# Chapel Ridge Apartments Rezoning & Preliminary Development Plan

PL2021-382

December 2, 2021

## High-impact Landscape Buffer

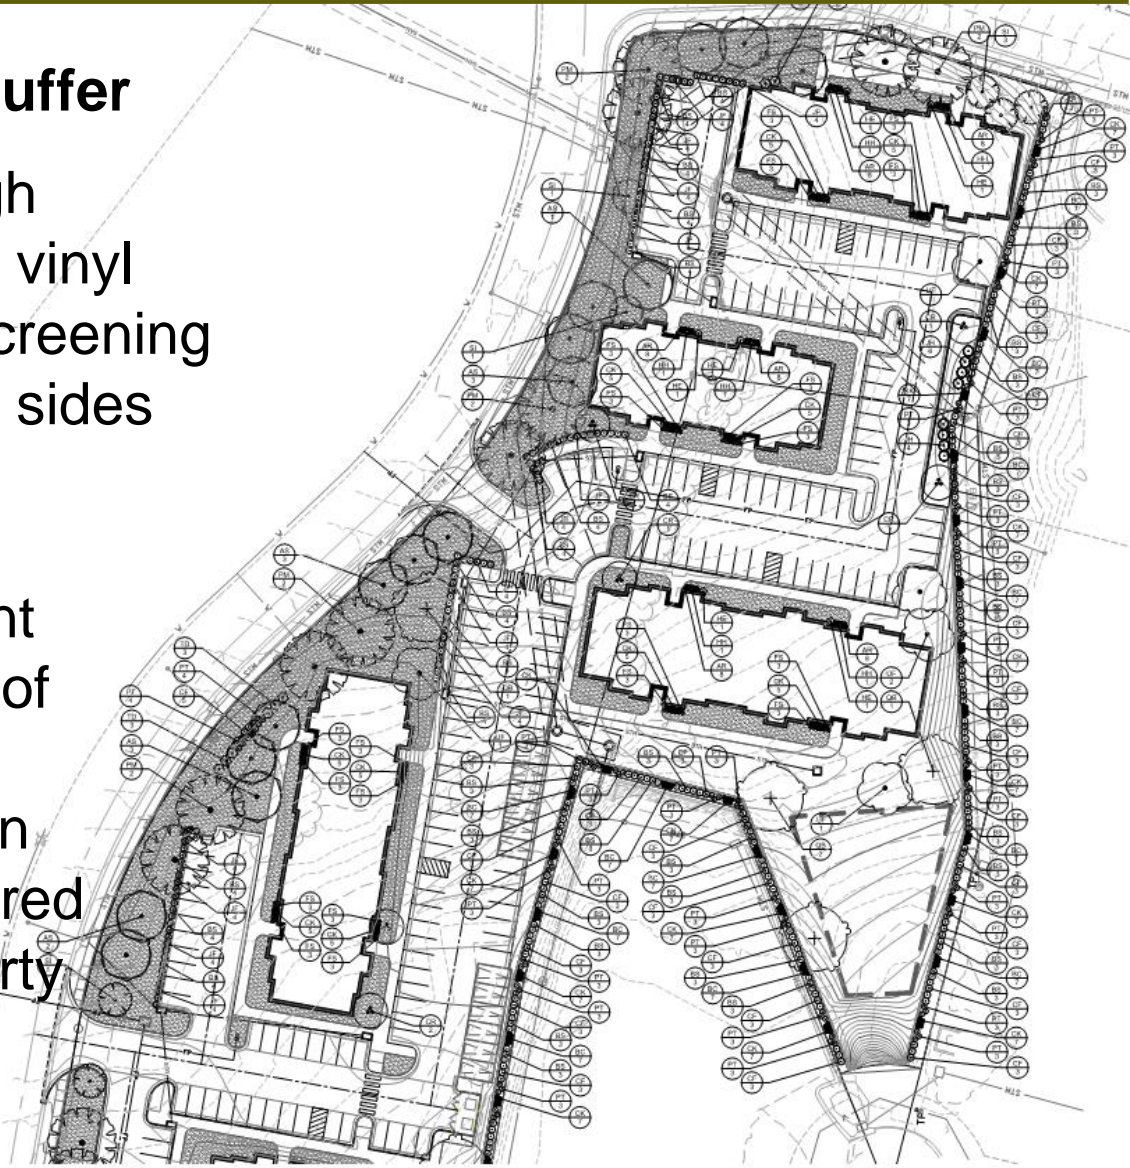
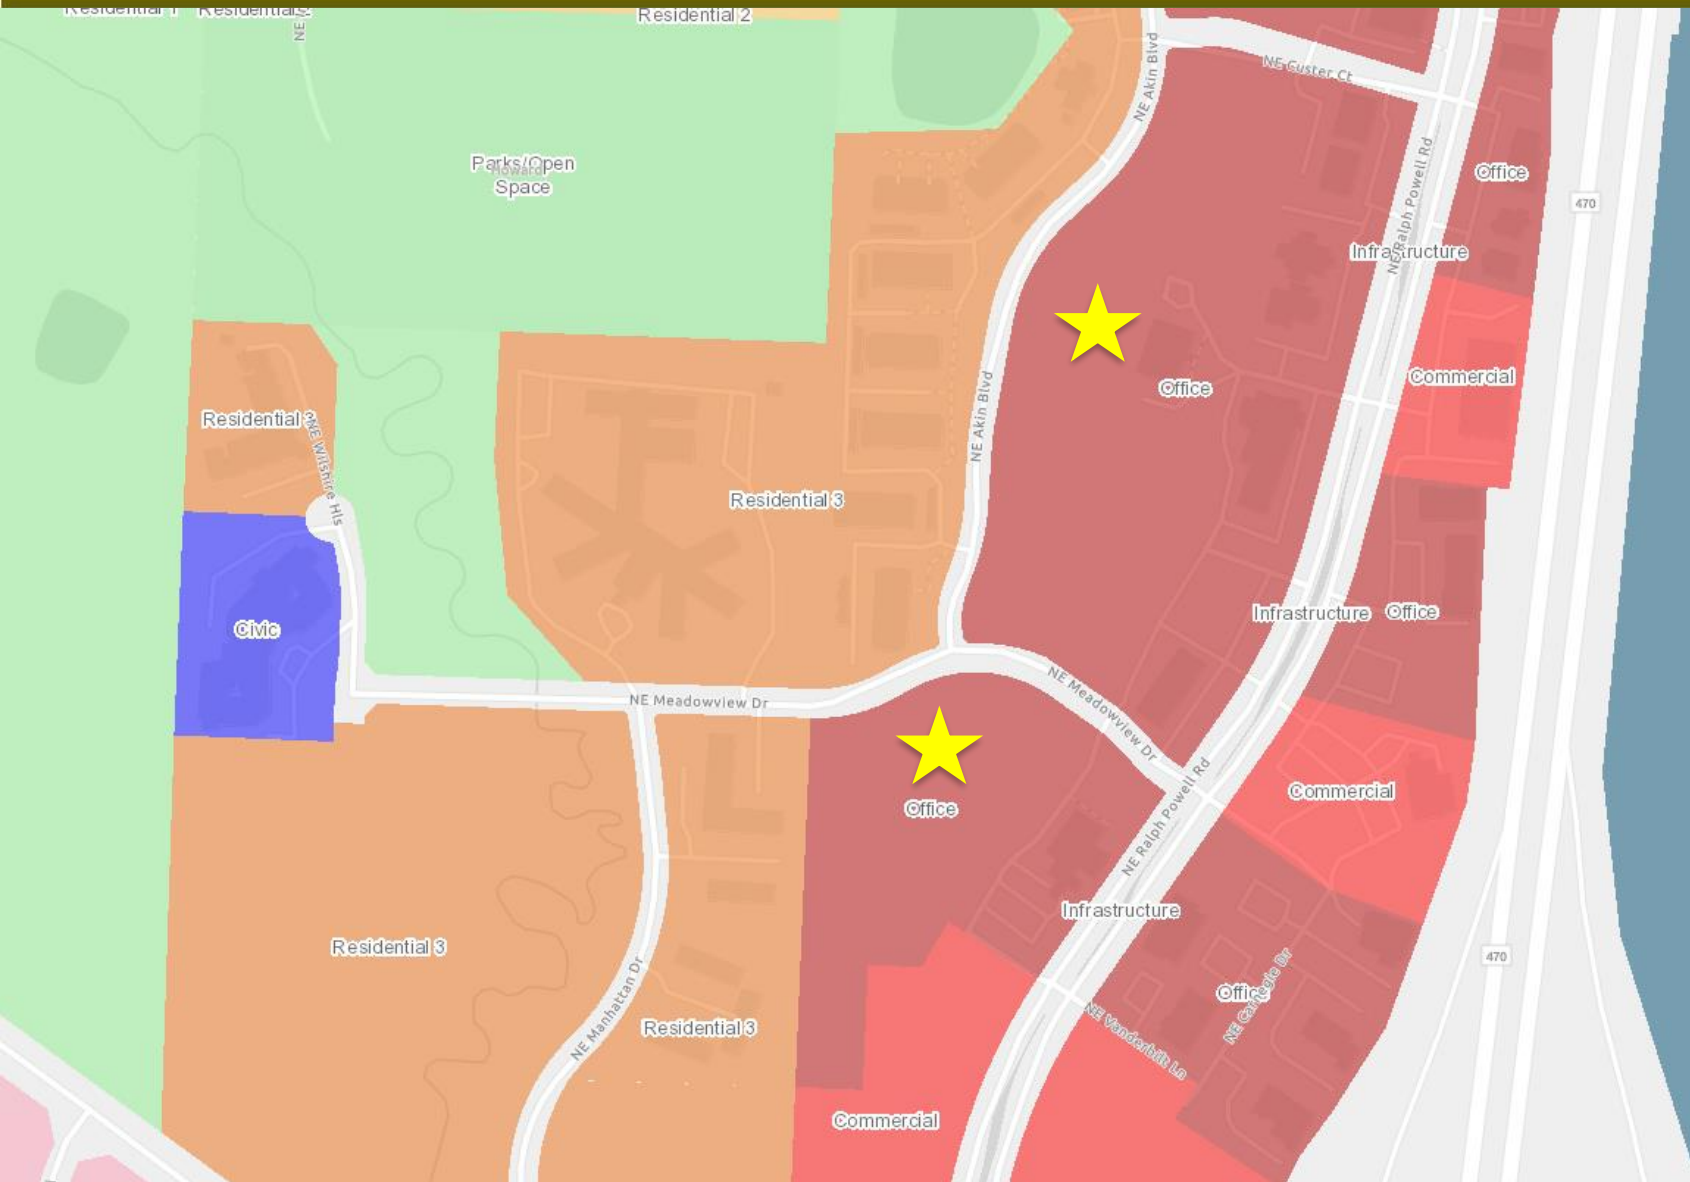
- **Required** – A six-foot high masonry wall or opaque vinyl fence and low impact screening shall be planted on both sides of the wall or the fence.
- **Proposed** – The applicant has requested approval of a landscaping plan that provides a natural screen buffer in lieu of the required 6' fence along the property line.

3. A modification of UDO Sec. 8.750 shall be granted to remove the required 6' high masonry wall or opaque vinyl fence from the high impact landscape buffer, with the landscape buffers to be installed in accordance with the submitted landscape plans dated November 1, 2021.
